Claim Number: A24-2003 B

PLACE OF USE OVERLAP REVIEW

Summary of Gregg Draney and Gleno Draney Claims
from old licenses.

Adjudication Claim no A24-2003A, A24-2003B, A24-2011A,
A24-2011B, A24-2022A, A24-2022B

TELEPHONE & VISITOR LOG

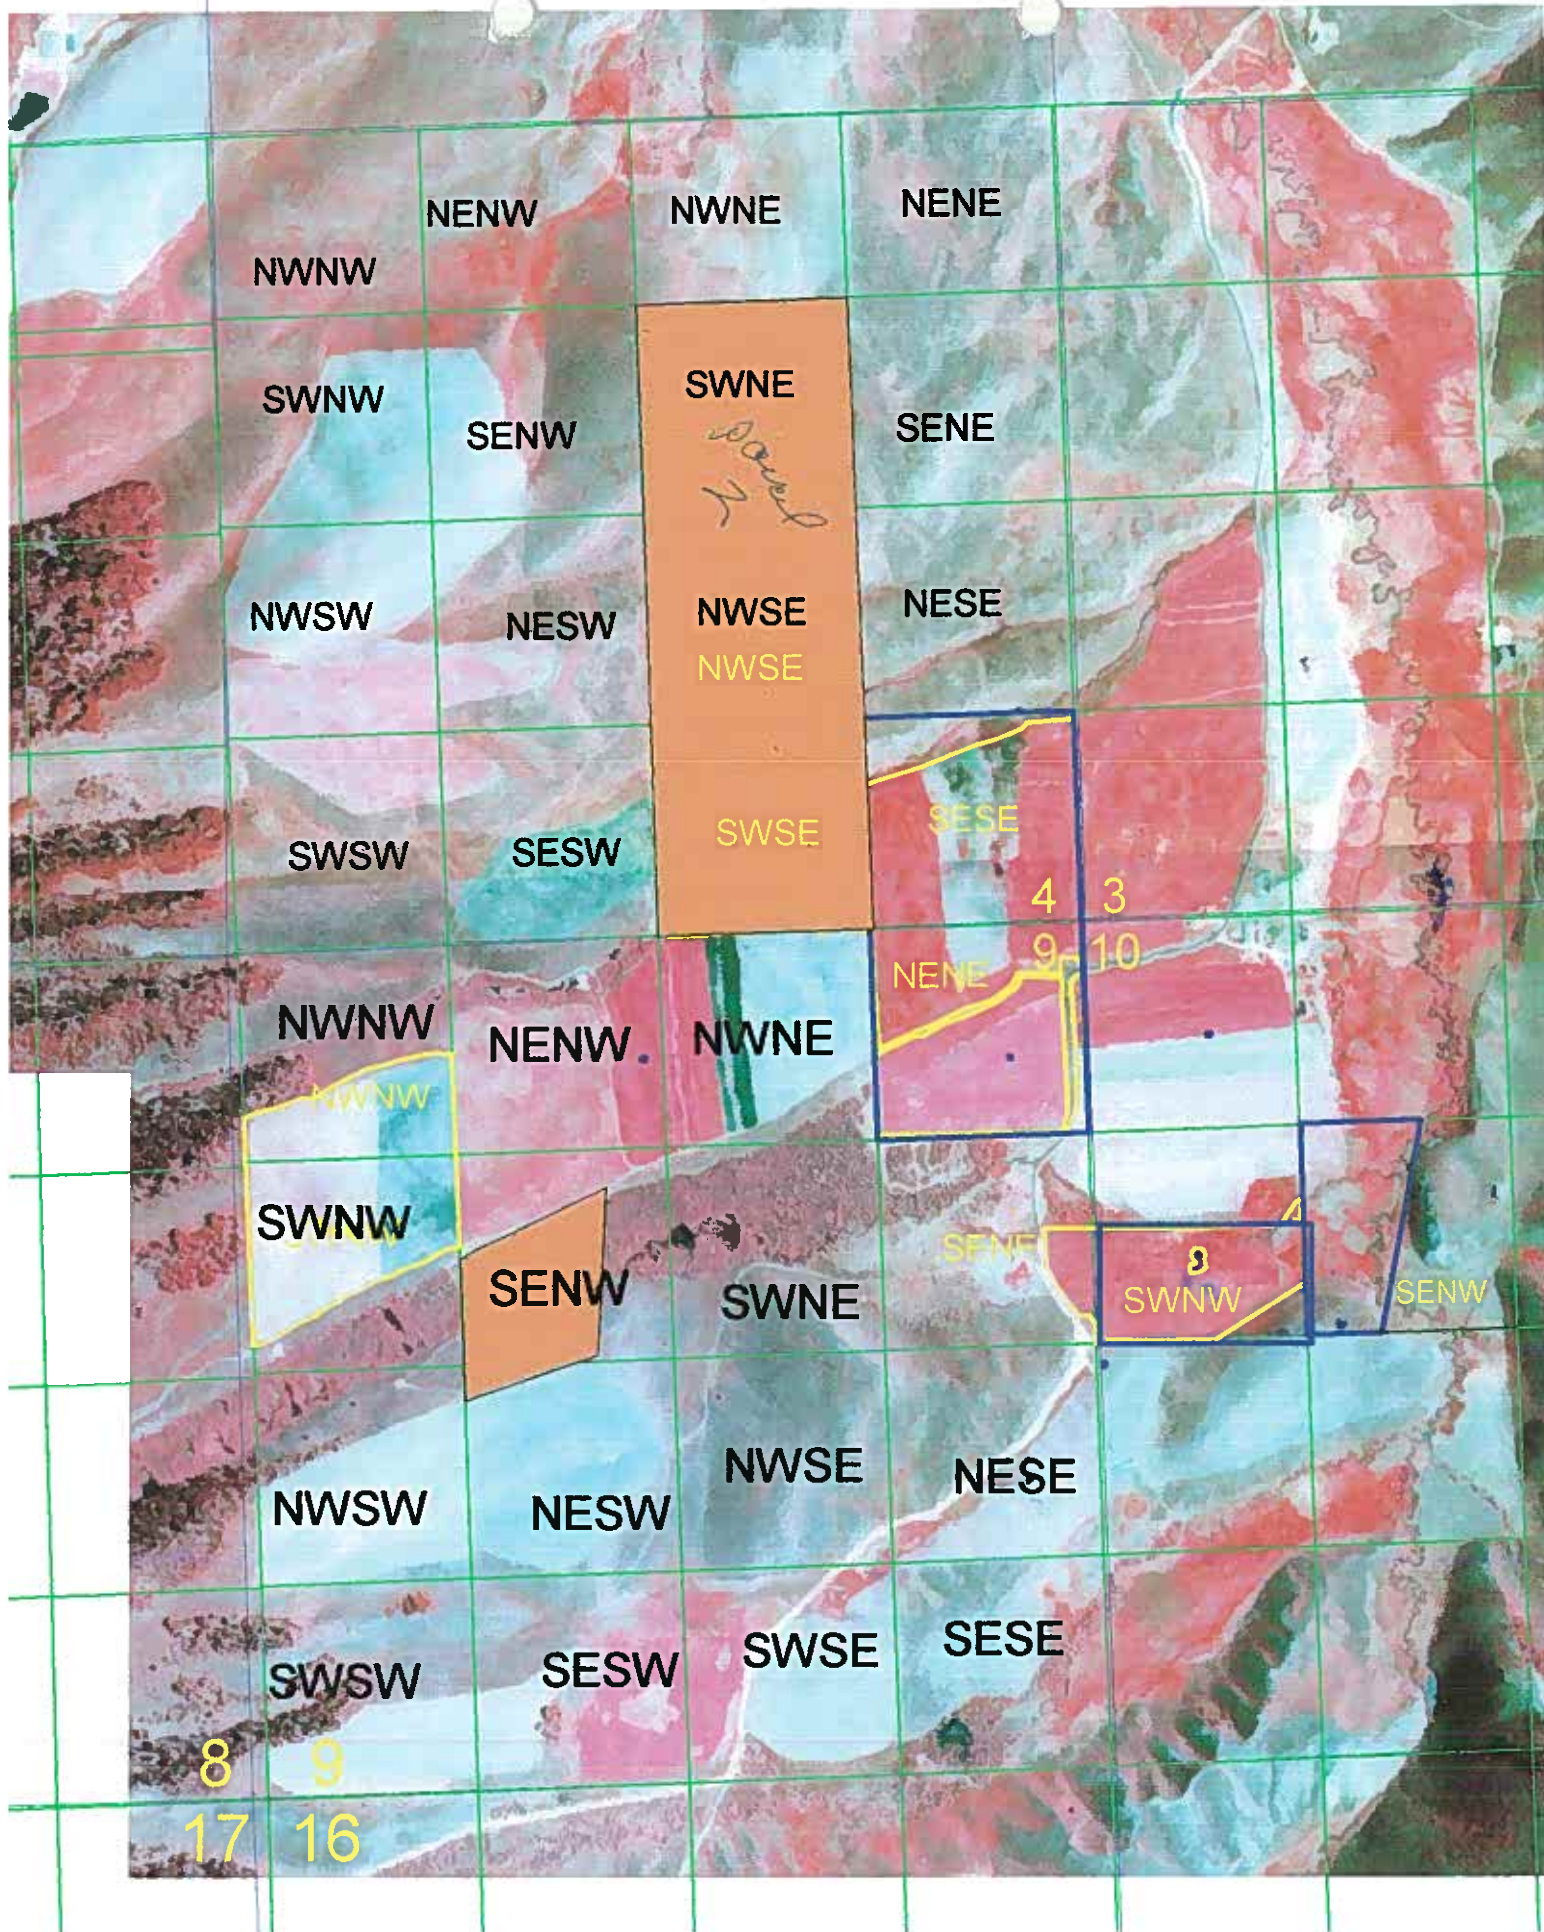
Conversation: Per the warranty deed we corrected the ownership layer for the B portion of these rights.

In the SWNW of section 10, it should be a rectangle of approximately 20 acres (S 1/2) and the W 1/2 SENW of section 10 is also approximately 20 acres.

Gregg Draney farms the NW corner of the SENW of section although it's owned by Zane. The SE corner of the SENE of section 9 is farmed by Zane →

although its owned by Gregg. They plan to do a deed swap of the land. But for now we will note within each file of the difference.

The PPU boundaries for both A & B needs to be adjusted in the SWNW of section 10 to stay within the boundary. The change in the overall total number of acres under both A & B that division rate was not adjusted.

Also the adjustment of the Poll shape for both rights is so small I'm not going to adjust the diversion rate. They would loose more than this in conveyance loss. CB

2004 Imagery

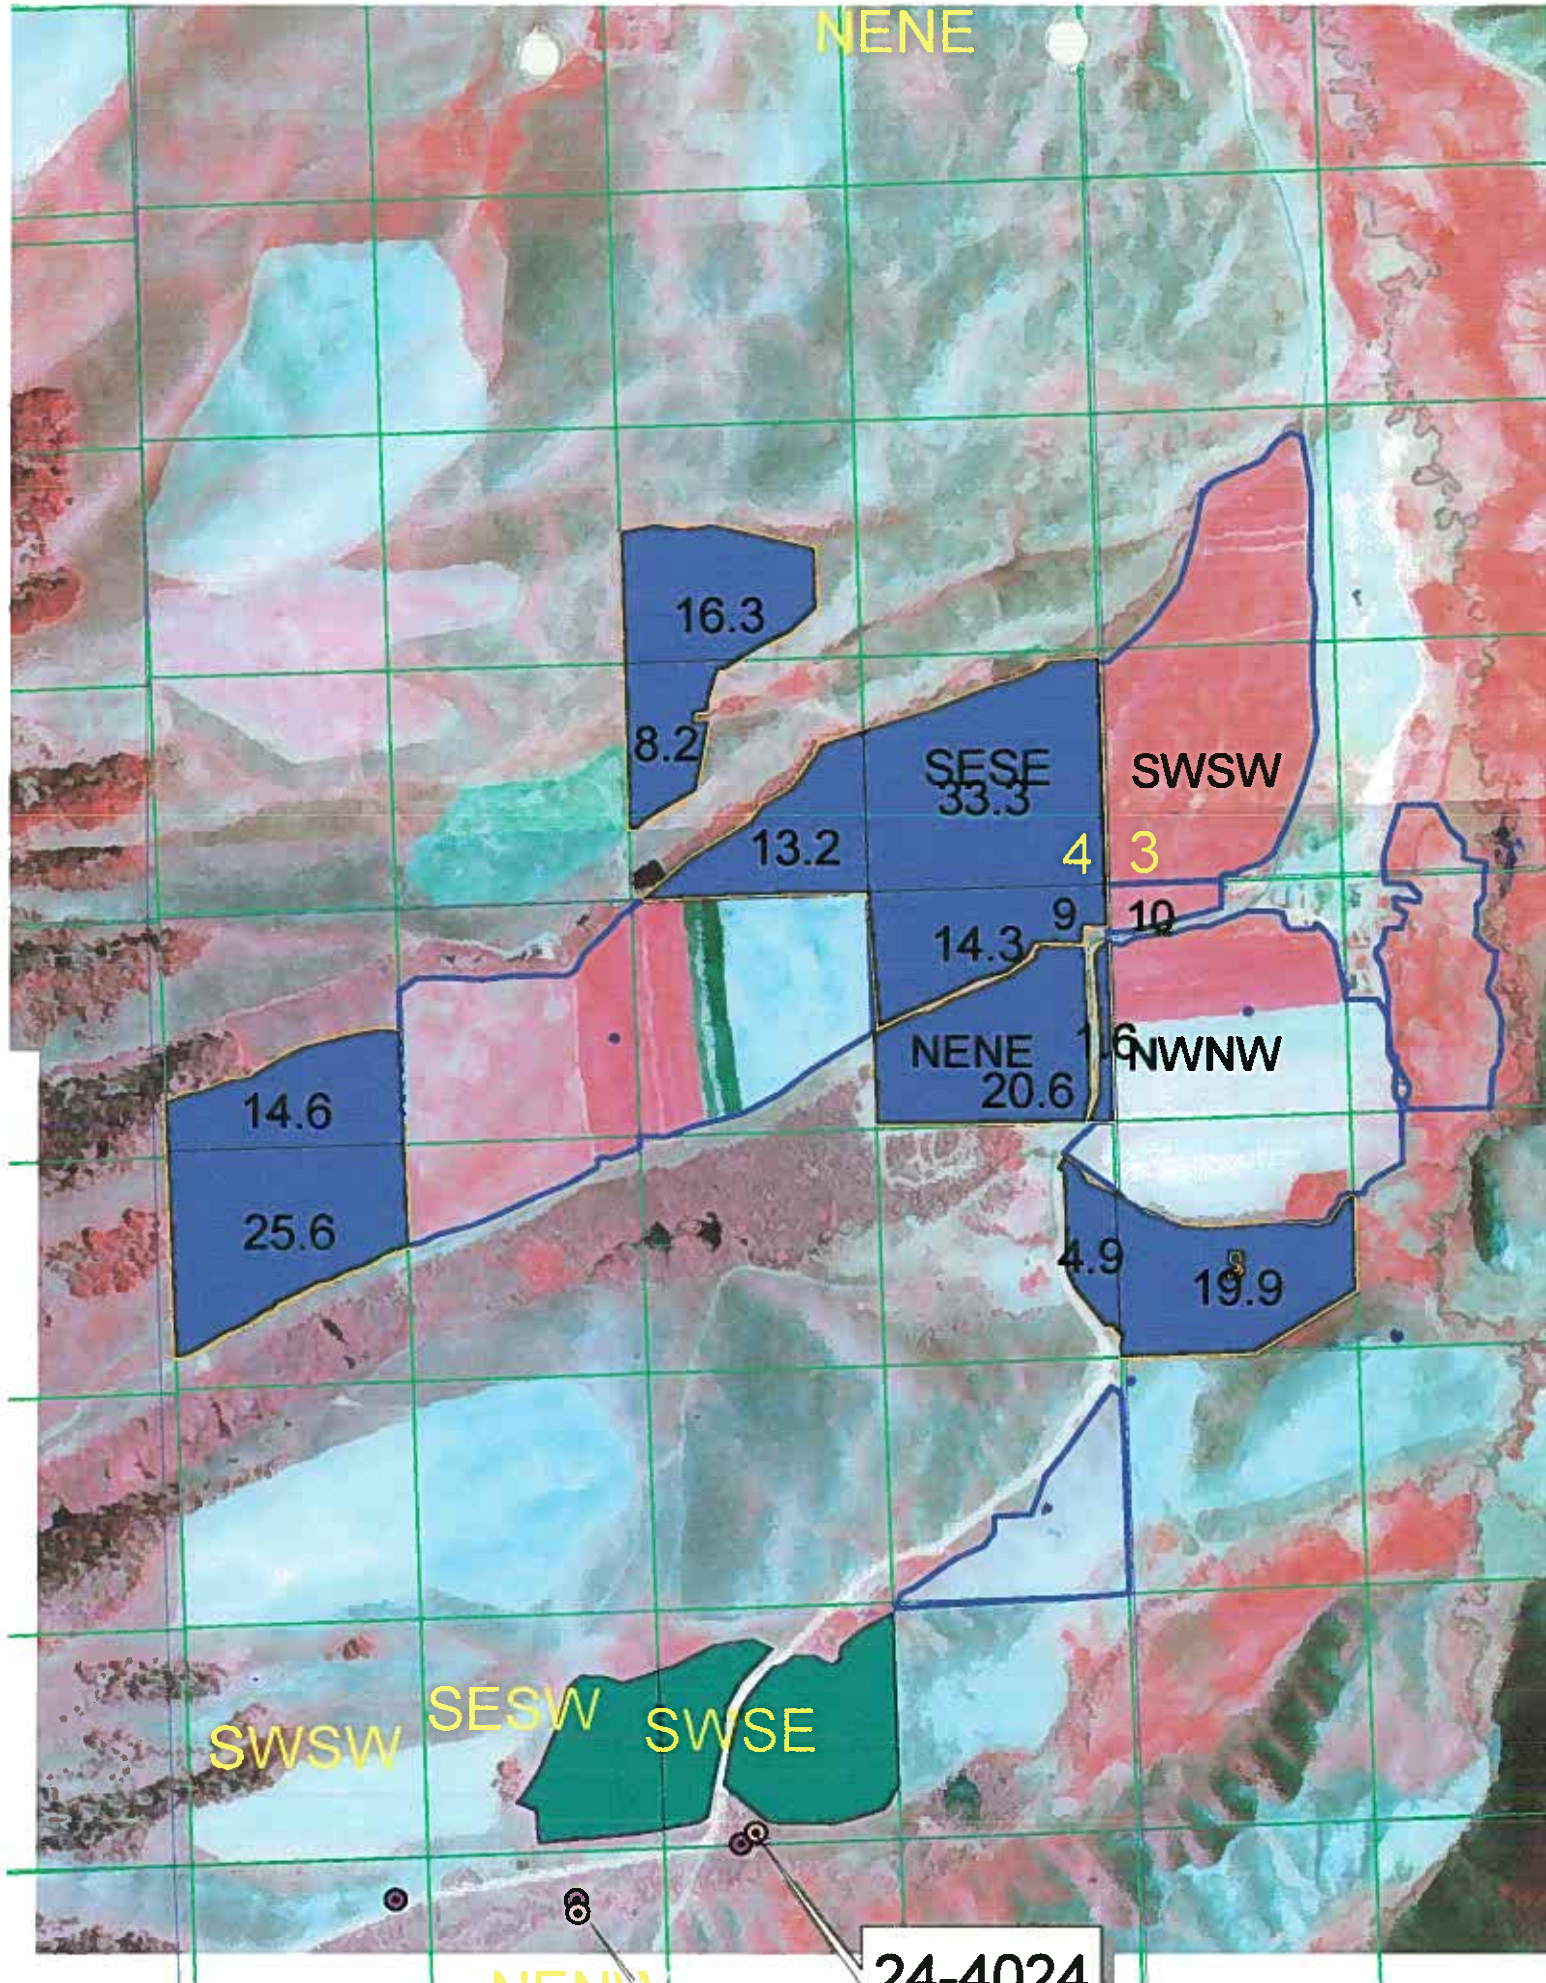
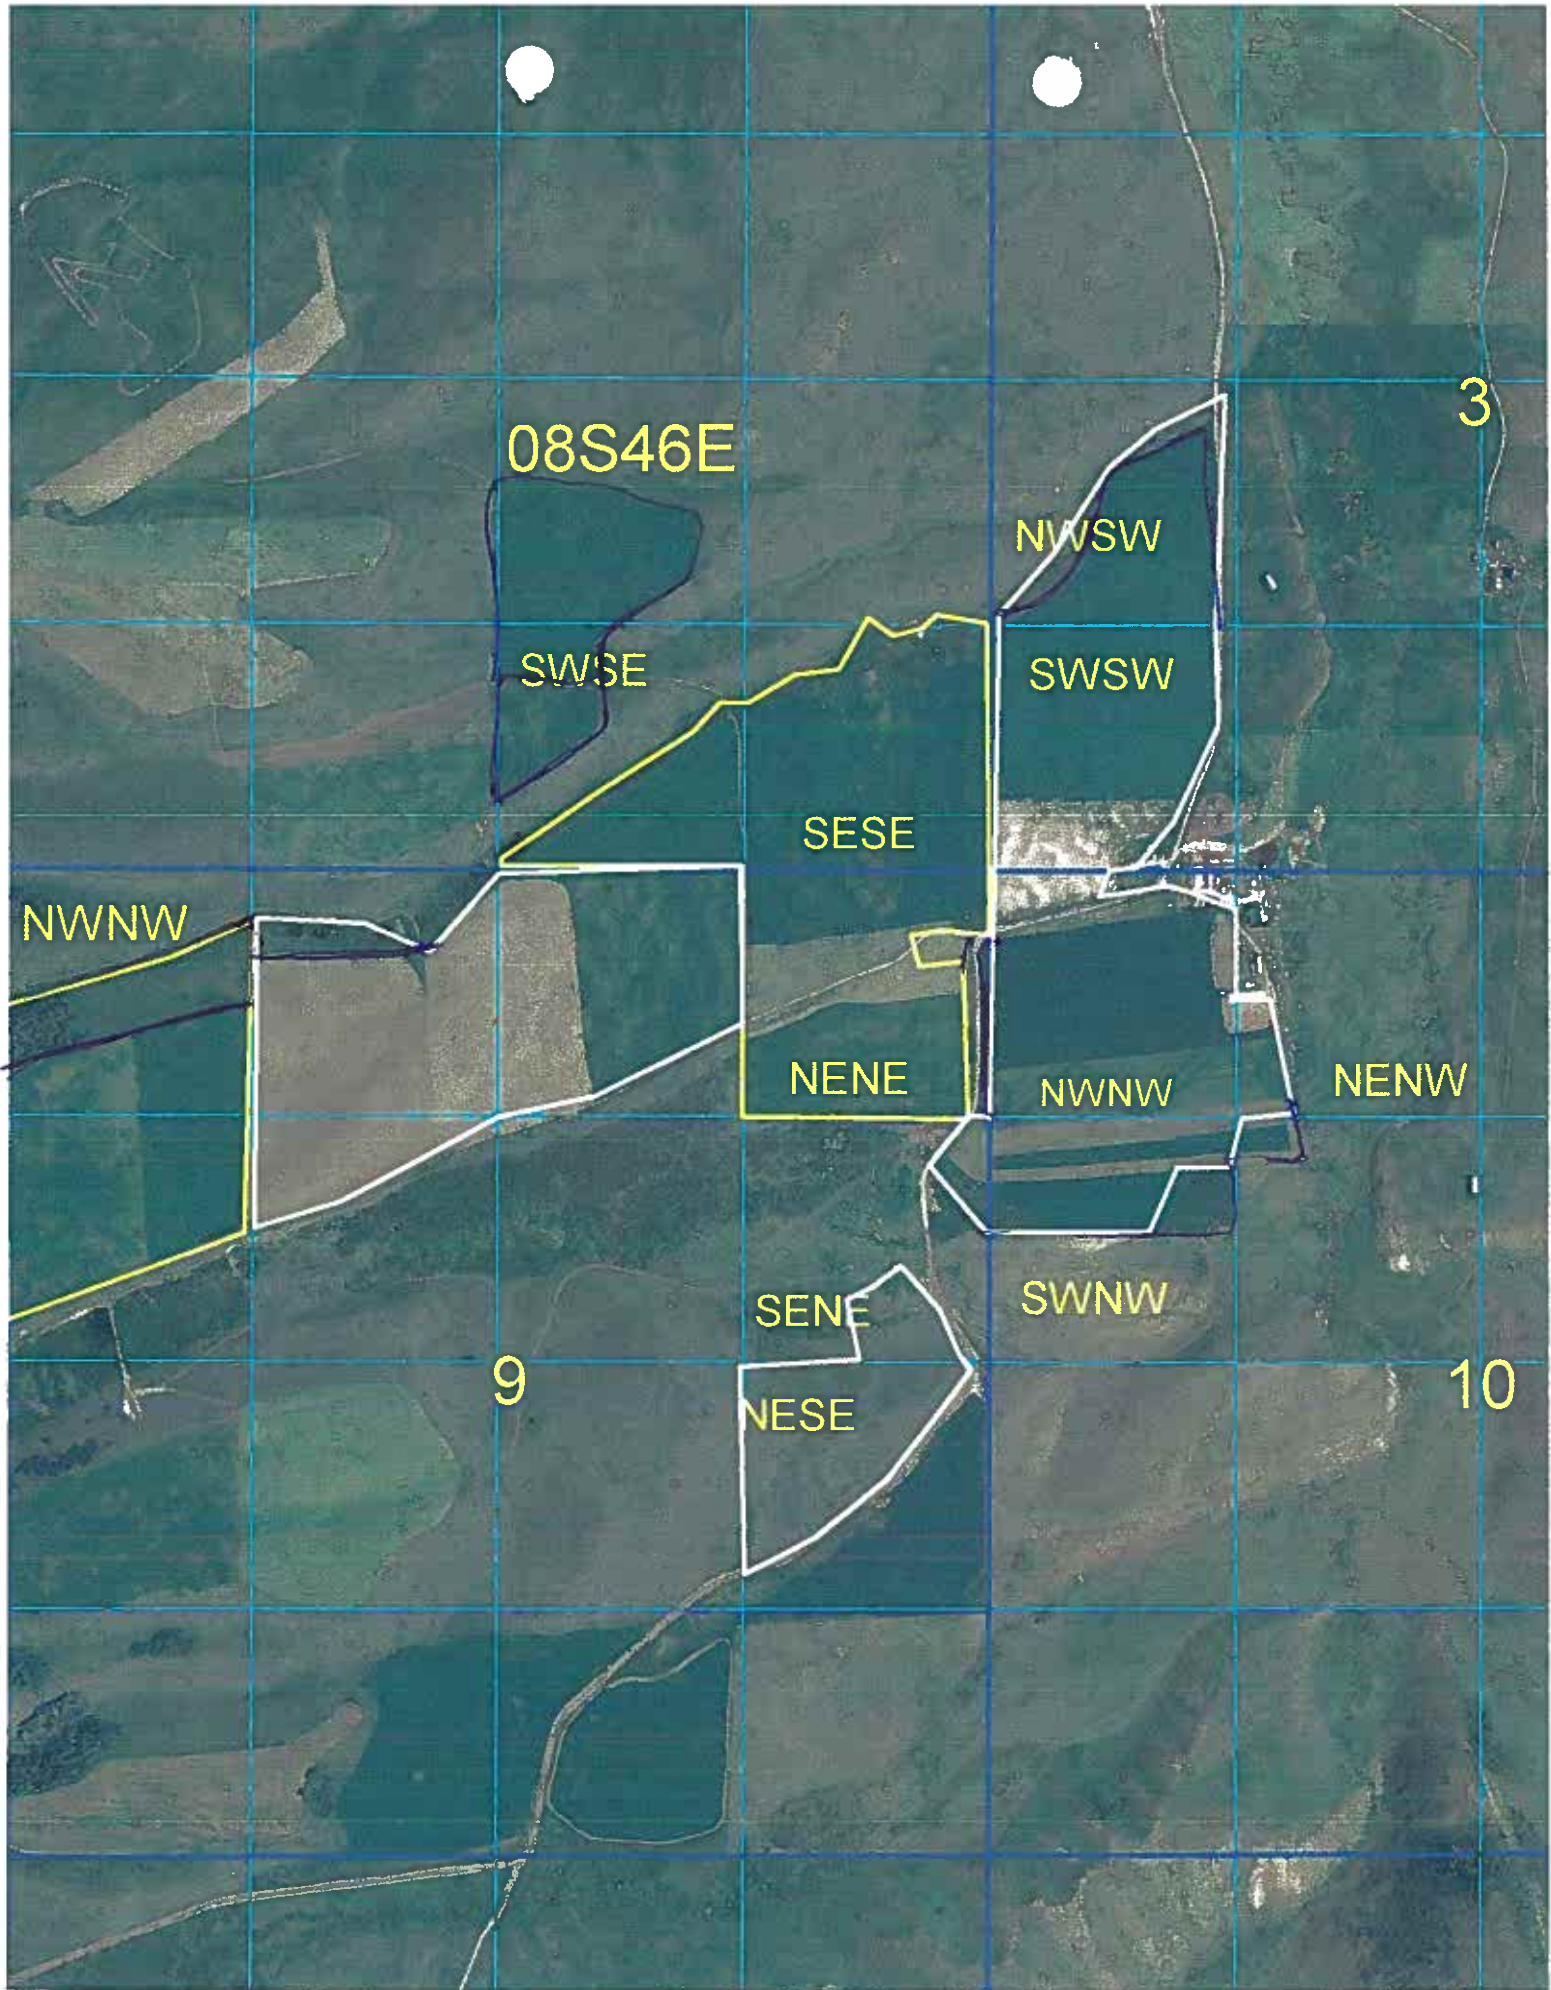
2003A 217.5

2003B 172.5.

4.35 cfs.

3.45 cfs
